Date: Thursday, March 09, 2023

Haverford Township Planning Commission

**3. PA Small Water & Sewer Program, DCED Small Water Sewer Grant Application
Sanitary Sewer Main Crossing – Naylor's Run Creek
Planning Commission Recommendation**

2. **774 Lawson Avenue, D.C. Folio No. 22-08-00649-00
Minor Subdivision Plan- Sleepy Valley Holdings, LLC**

PREPARED BY: YOHN ENGINEERING, LLC P.O. BOX 26094 COLLEGEVILLE, PA 19426 610-489-4580 WWW.YOHNEENGINEERING.COM	SHEET: 6 OF 7
---	----------------------

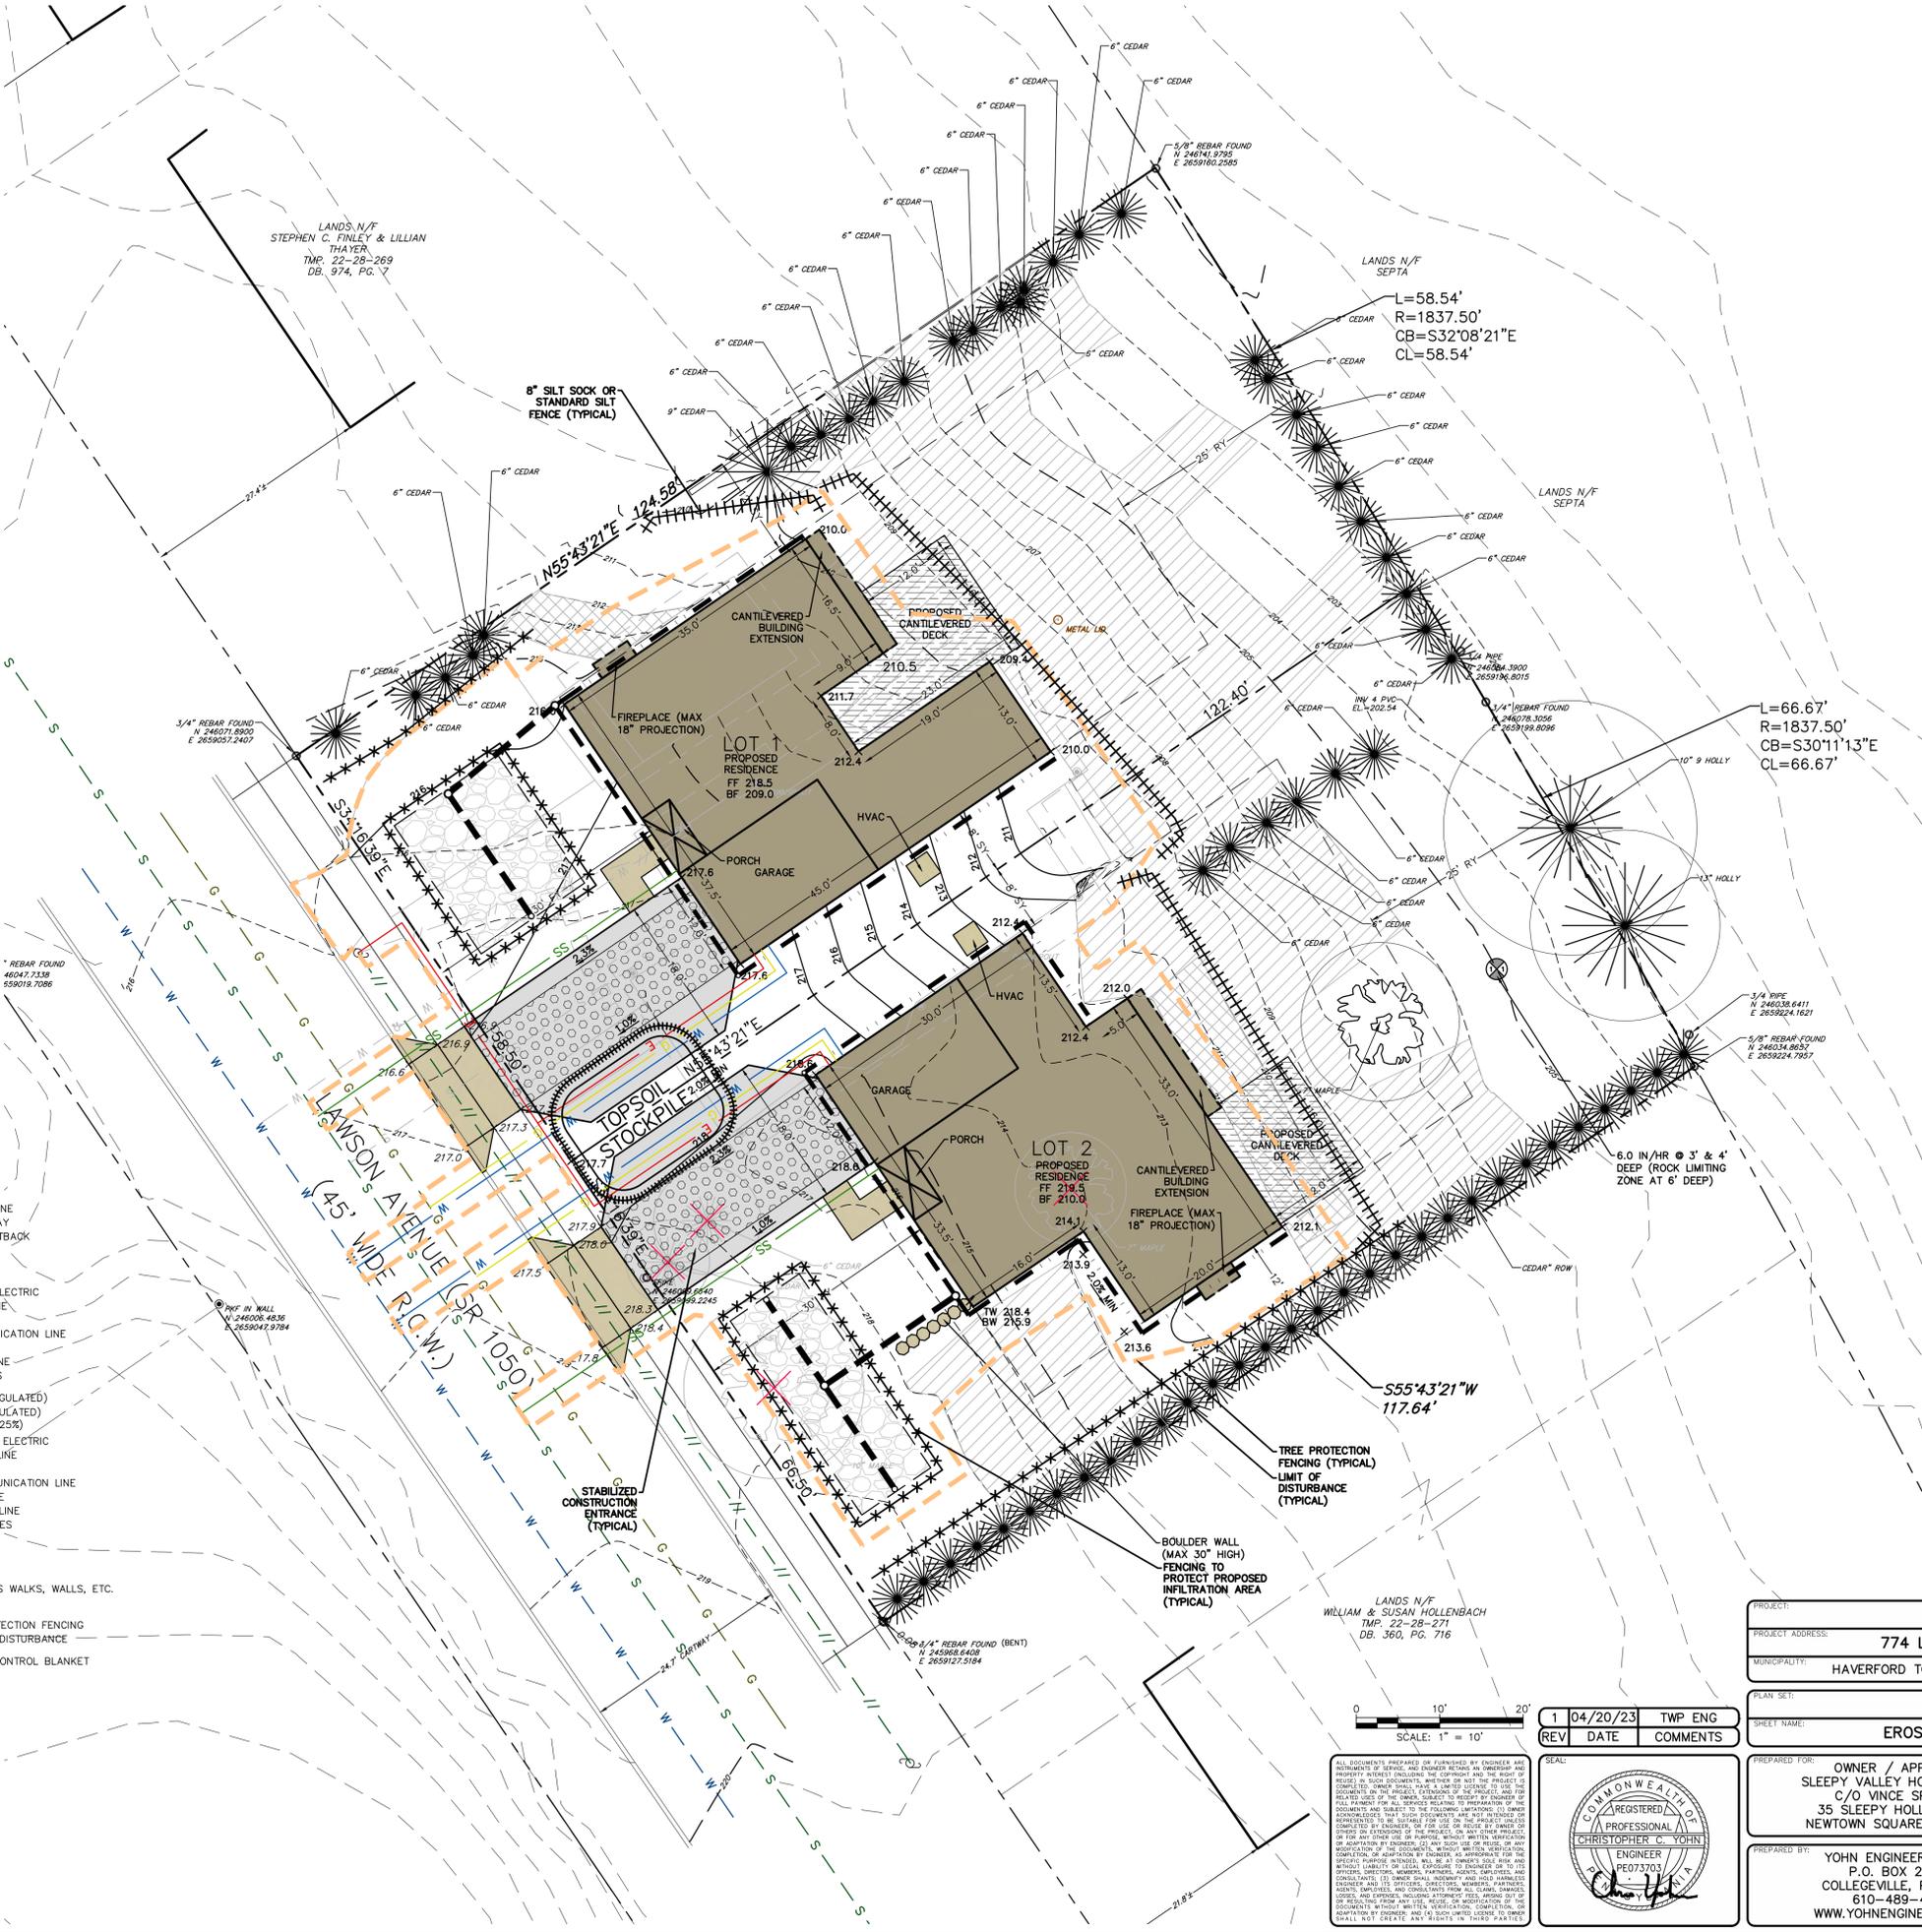
2. The applicant should delineate the areas of disturbance on the plan and provide the percentage of slopes on Lot 2 that will be disturbed. *A chart has been provided on sheet 6, Erosion and Sediment Control Plan*

5. The plans have been revised to show the disturbance required within the steep slopes and to provide a calculation of percent disturbed as shown on sheet 6.
